Title: **STAGE 1 ROAD SAFETY AUDIT**

**Proposed Strategic Housing Development at Great Connell,
Newbridge, Co. Kildare**

Client: **Aston Ltd**

Report reference: **1428R01**

Drawing 192229-PUNCH-XX-XX-DR-C-0431 Rev P01.05, Tie-in of cycle tracks on Great Connell Road.

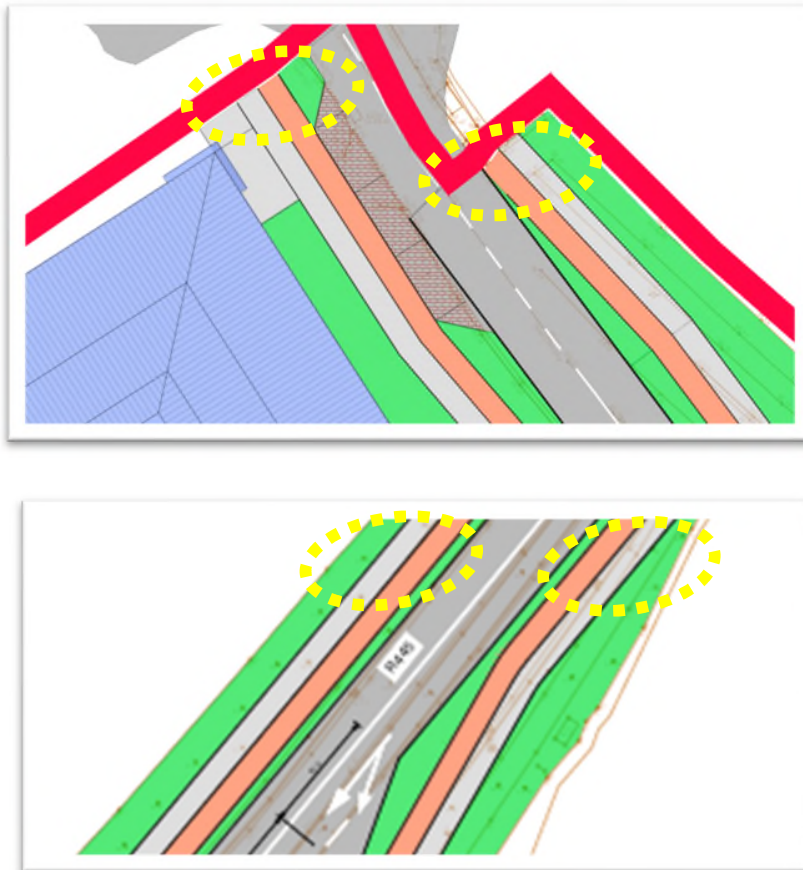
The drawings show proposed cycle tracks on the Great Connell Arms of the signalised junction in lieu of the existing roundabout. There are no existing cycle facilities for cyclists to join with. A lack of continuity of provision for cyclists could lead to cyclists opting to travel on the carriageway where they would be at greater risk of being involved in a collision with a passing vehicle or of losing control as they attempt to merge on-road by crossing the verge and high kerbs.

It is recommended that suitable interim and permanent tie-in arrangements be provided for cyclists both at the NSORR junction and the Buckley's cross junction.

3.1	Y	N	<p>Great Connell Signalised Junction</p> <p>As an interim measure ‘Cyclist Dismount’ markings and dropped kerbs at the end of the cycle lanes will be included at the end of each leg of the footpath/cycle paths on the Great Connell Road signalized Junction as part of the Stage 2 Detailed Design of the Project.</p> <p>Any permanent measure to introduce cycling lanes on Great Connell Road are outside the blue line (land ownership) and red line (planning application) boundaries of this SHD application and should be considered by Kildare County Council as part of any future upgrade works on the Great Connell Road</p> <p>Buckley’s Cross Signalised Junction</p> <p>Buckleys Cross signalized junction does not form part of this planning application. The junction layout has been prepared to demonstrate to Kildare County Council that a Signalised Junction compliant with the requirements of “TII document DN-GEO-03044-02 Signal Controlled Junctions and Roundabouts” can be delivered by Kildare County Council within publicly available lands.</p>	Yes

Paragraph No. in Safety Audit Report	Problem accepted (yes/no)	Recommended measure accepted (yes/no)	Alternative measures (describe)	Alternative measures accepted by Auditors (Yes/No)
			<p>Kildare County Council should consider an interim measure of including 'Cyclist Dismount' markings and dropped kerbs at the end of the cycle lanes on each leg of the footpath/cycle paths on the Buckleys Cross Junction as part of any future upgrade.</p> <p>Any permanent measure to introduce cycling lanes should be considered by Kildare County Council as part of any future upgrade works on the R445 Dublin Road</p>

Drawing 192229-PUNCH-XX-XX-DR-C-0628 Rev C01

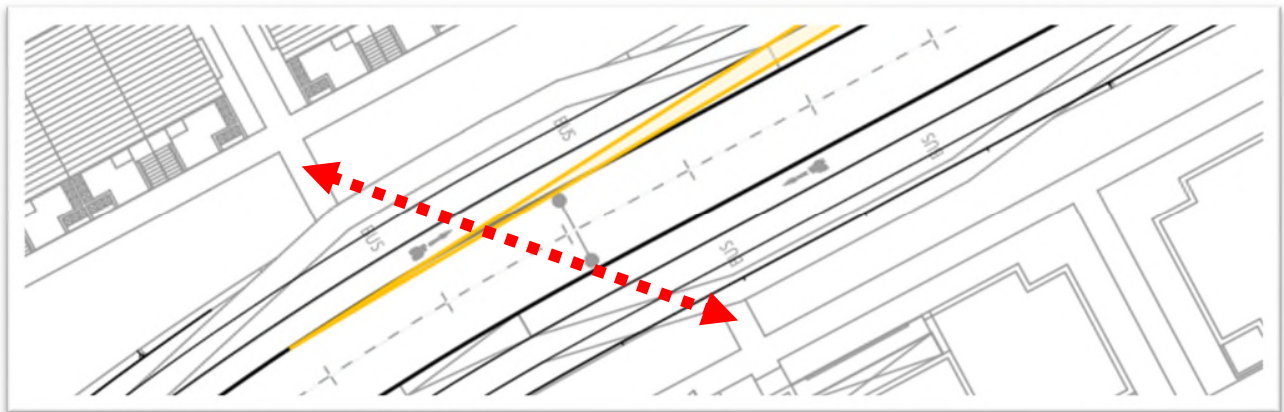
It is proposed to provide bus layby-s on the extension of the NSORR west of the signalised junction. There is a risk that there will be pedestrian desire lines to cross the NSORR closer to the bus stops and that pedestrians will not use the proposed crossings at the signalised junction or the toucan crossing west of the bus stops. Crossing without priority on an arterial route with a 60km/hr speed limit could lead to collisions with passing vehicles.

It is recommended that the Design Team assess the potential desire lines from the residential areas and provide an additional controlled crossing if required.

3.2	N	N	<p>Approximately 350m length of the NSORR is being provided within this Great Connell SHD application. Toucan Crossings are provided at the Great Connell Signalized Junction and at a point some 250m to the southwest. The Toucan Crossings are thus approximately 100m to the northeast and southwest of the proposed bus stop locations. It is considered that there is a sufficient level of crossing points to provide safe overall access for pedestrians/cyclist considering the low-speed environment along this section of the NSORR. The crossing points were agreed previously with Kildare County Council Roads Department. At Stage 2 Detailed Design Stage the final positions of bus stops and Toucan crossings will</p>	Yes

Paragraph No. in Safety Audit Report	Problem accepted (yes/no)	Recommended measure accepted (yes/no)	Alternative measures (describe)	Alternative measures accepted by Auditors (Yes/No)
			be signed off by Kildare County Council and the NTA

Drawing 192229-PUNCH-XX-XX-DR-C-0628 Rev C01, Sightlines through parking spaces

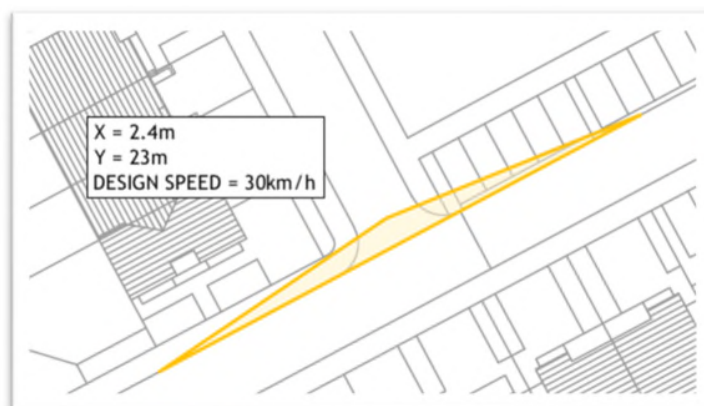
Some sightlines on the internal road network cut through the perpendicular car parking spaces. This may lead to a lack of visibility for drivers who may enter the carriageway at an inappropriate time resulting in side-impact or rear-end collisions.

It is recommended that visibility splays be kept clear of obstacles that affect visibility.

3.3	N	N	The perpendicular carparking bays impacted by the visibility splays are limited and occur on low-speed roads i.e. 30kph and it is considered that a relation is warranted. DMURS Section 4.4.5 allows for flexibility in relation to visibility splays cutting through carparking spaces on low-speed roads.	Yes
